**DEVELOPMENT REVIEW COMMISSION
STAFF REPORT**

CASE NO.: 20-31000018 PLAT SHEET: K-21

REQUEST: Approval of a modification to an already approved Site Plan to include an adjacent property for the construction of a self-storage facility with three (3) requested variances in the CCS-2 zoning district.

ADDRESS: 4017 34th Street South

SOUTH BUFFER CONDITION
SECTION A-A

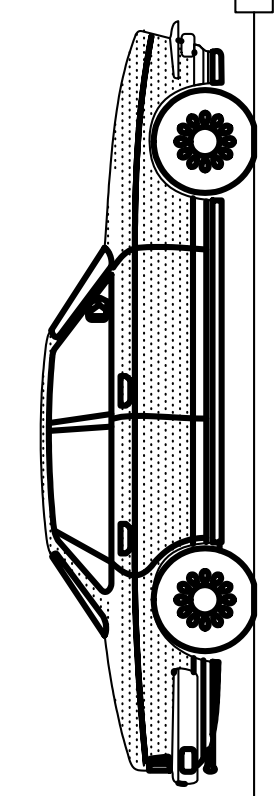
The variance request from Section 16.50.400.4.B will be mitigated by a current 6-foot tall masonry wall. The existing wall can not structurally support additional height, so the applicant is to provide a continuous hedging creating approximately more than 8-feet of screening.

This existing masonry wall and new hedging will also be incorporated to mitigate development standards for screening of a loading dock. Section 16.50.400.4.F requires a minimum of 8' screening from adjacent properties. As proposed, the wall and hedge will exceed this requirement.

1 EAST ELEVATION
SCALE: 3/32" = 1'-0"

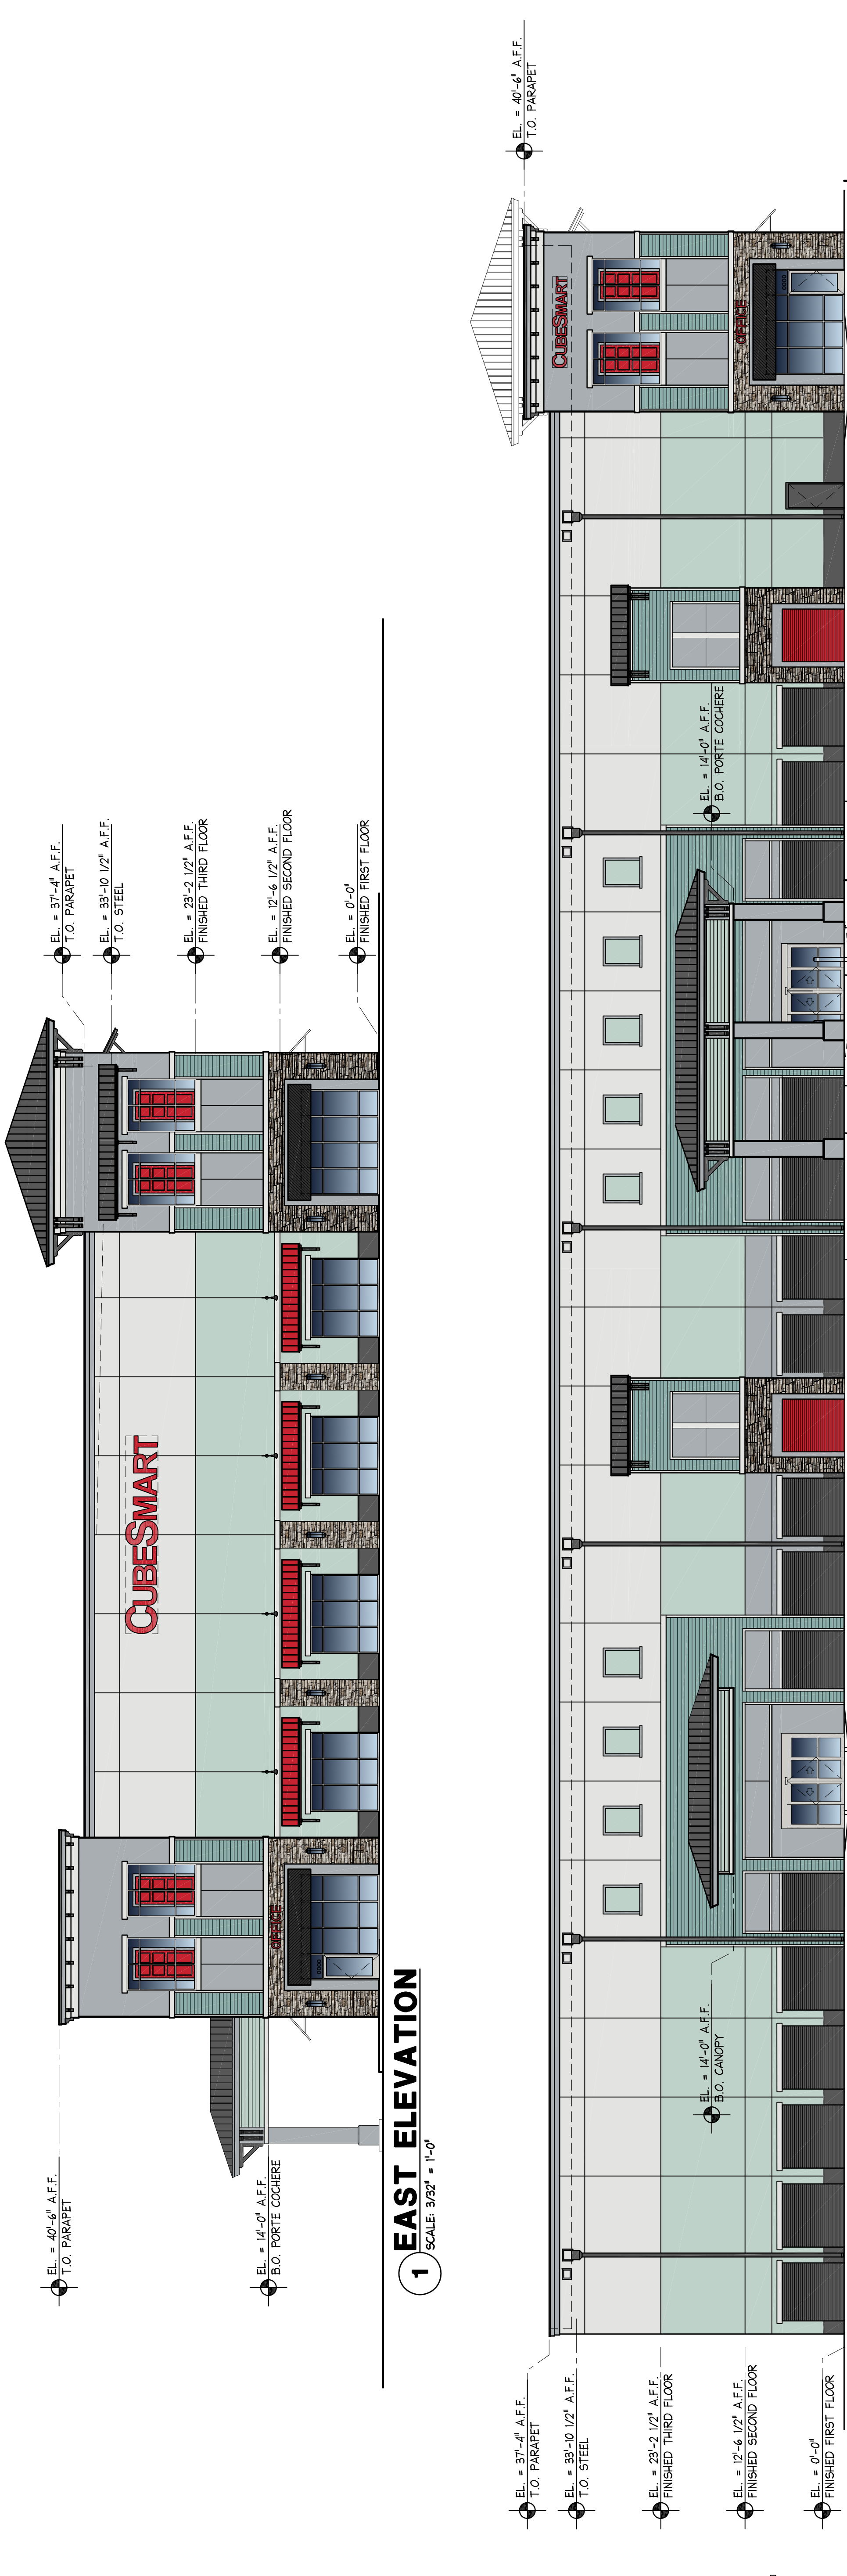
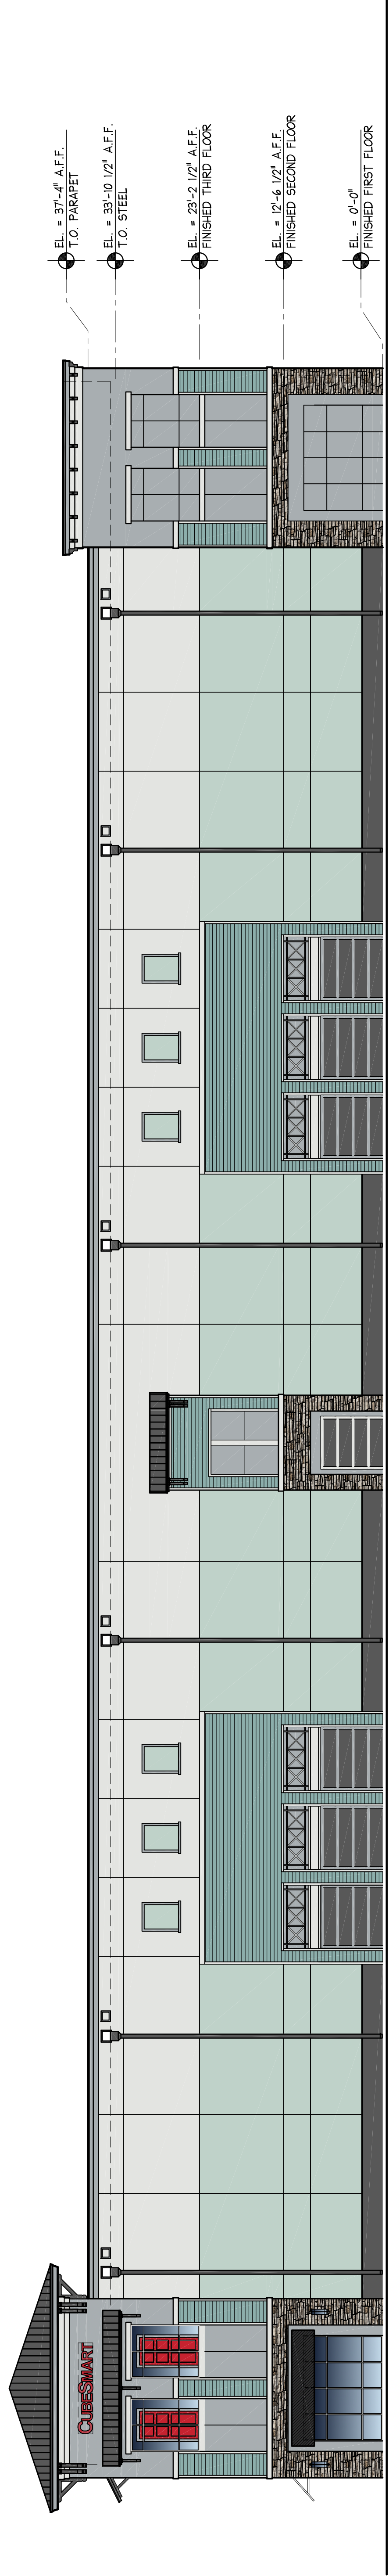
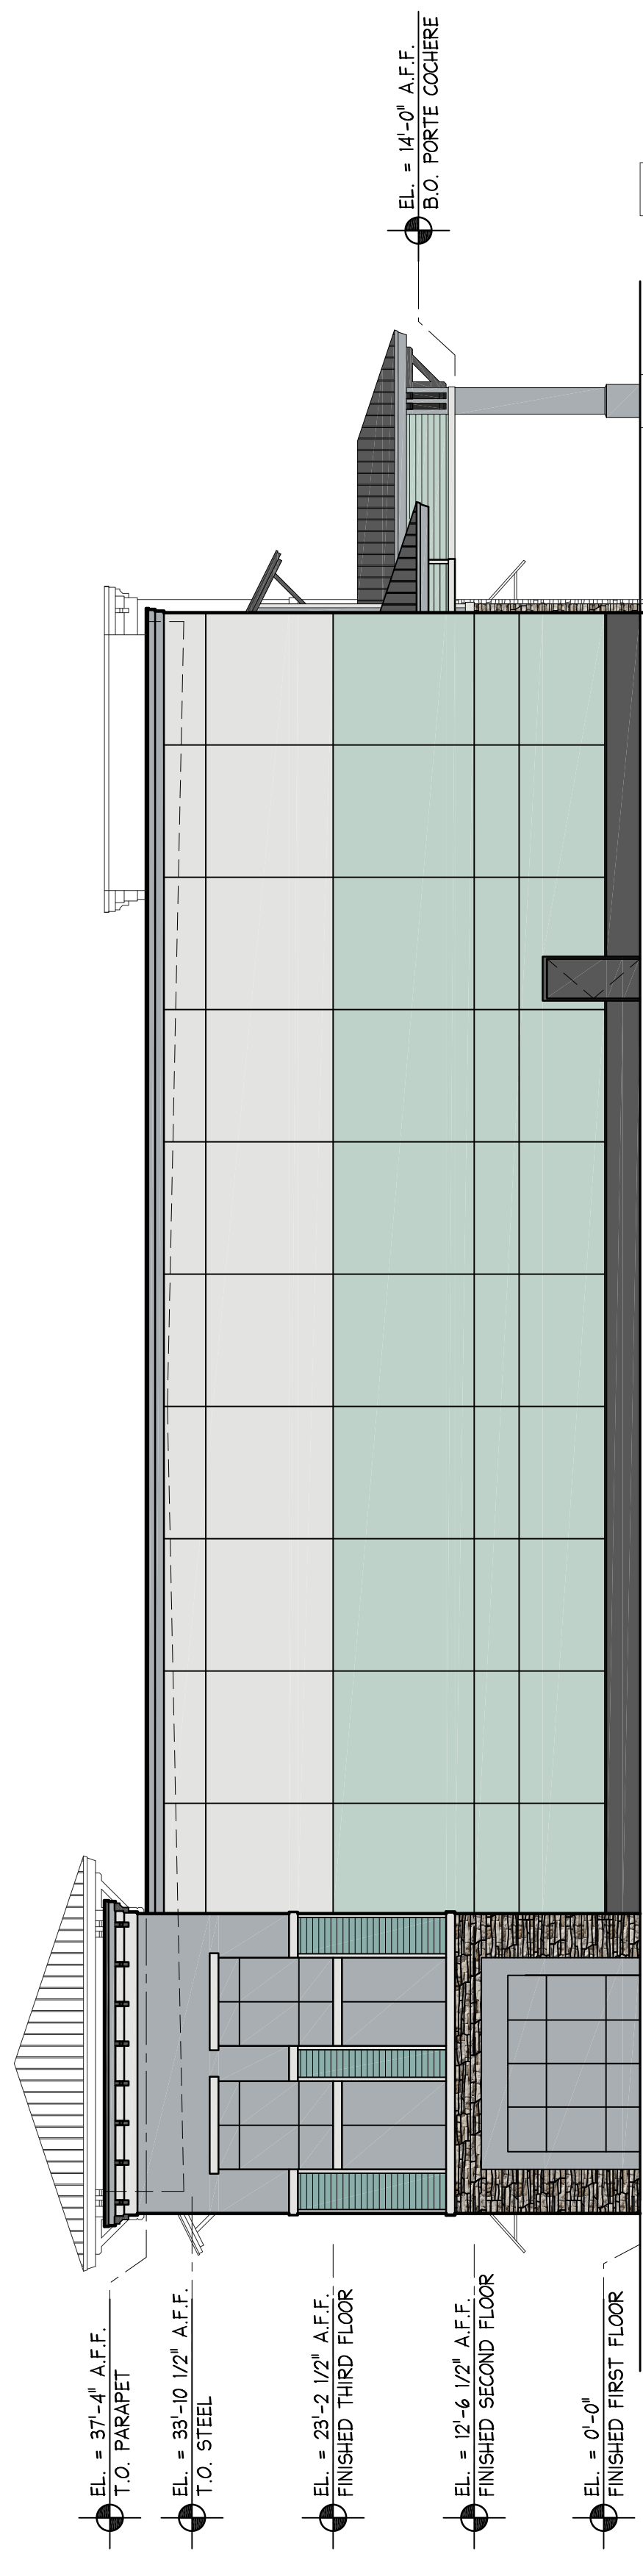
The proposed storage building is a contemporary style of architecture. The building design incorporates architectural elements that are used on the buildings of the multi-family portion of the development. These elements should create interest in the façade. The structure has been articulated with a change in materials, roofing elements, projecting wall features, multi-story tower features that include glazing, at the corners of the building. The plane of the façade also incorporates projecting wall features.
